STAFF REPORT
KETCHUM PLANNING AND ZONING COMMISSION
REGULAR MEETING OF SEPTEMBER 9, 2019

PROJECT: 220 Lava Street Single-Family Residence

FILE NUMBER: P19-085

APPLICATION TYPE: Mountain Overlay Design Review

CONCEPTUAL PERSPECTIVE FROM INTERSECTION (4th ST EAST + EAST AVE.)

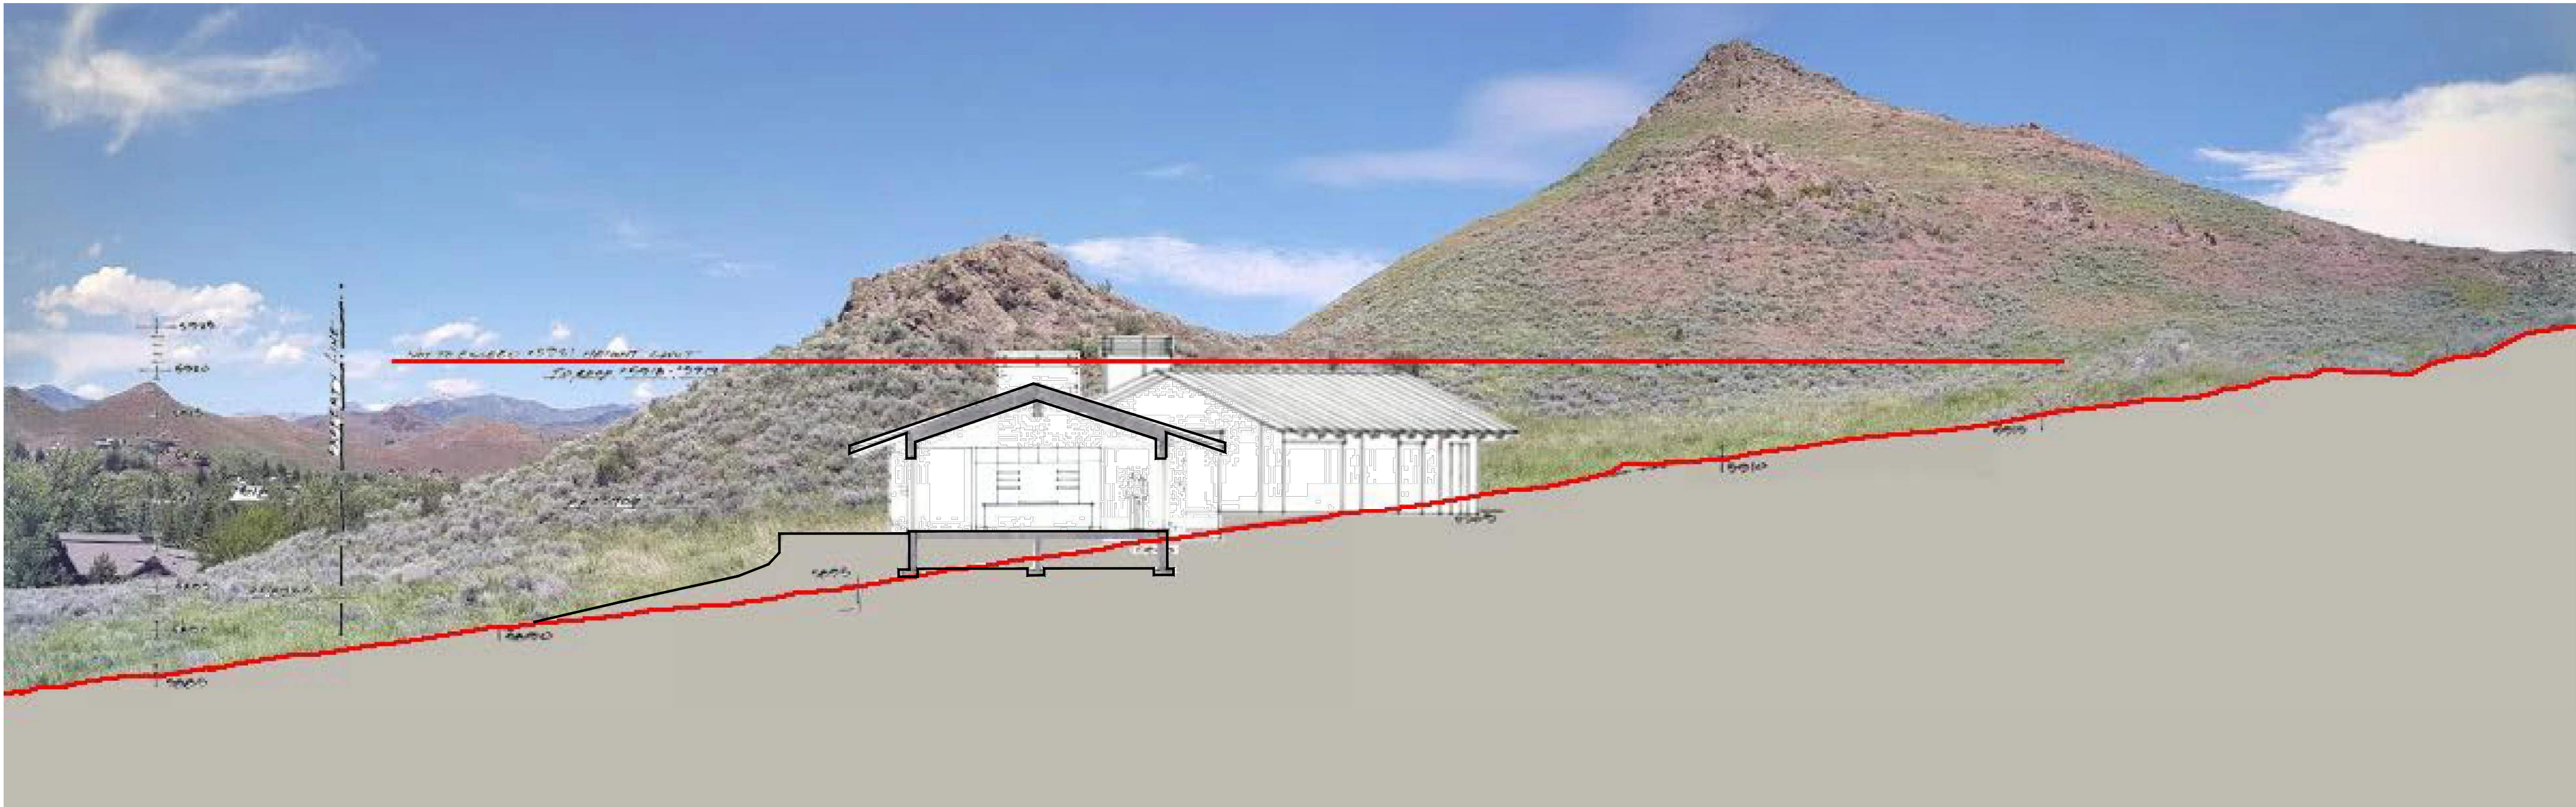
Staff Comment: With the Pre-Application MO Design Review submittal, the applicant included a conceptual perspective from the intersection of 4th Street and East Avenue. The perspective image included landscaping with healthy green foliage, which serves to enhance screening. During review of the Pre-Application, the Commission commented that the proposed Swedish Aspens will not provide the same degree of screening during the fall and winter seasons when the trees lose their foliage. The Commission recommended installing Douglas Fir trees instead of Swedish Aspen to enhance screening the single-family residence on the hillside from this view corridor. As indicated on Sheet L2 of the MO Design Review submittal, the applicant modified the landscape plan and has proposed installing ten Evergreen trees to screen the building from the intersection of East Avenue and Fourth Street.
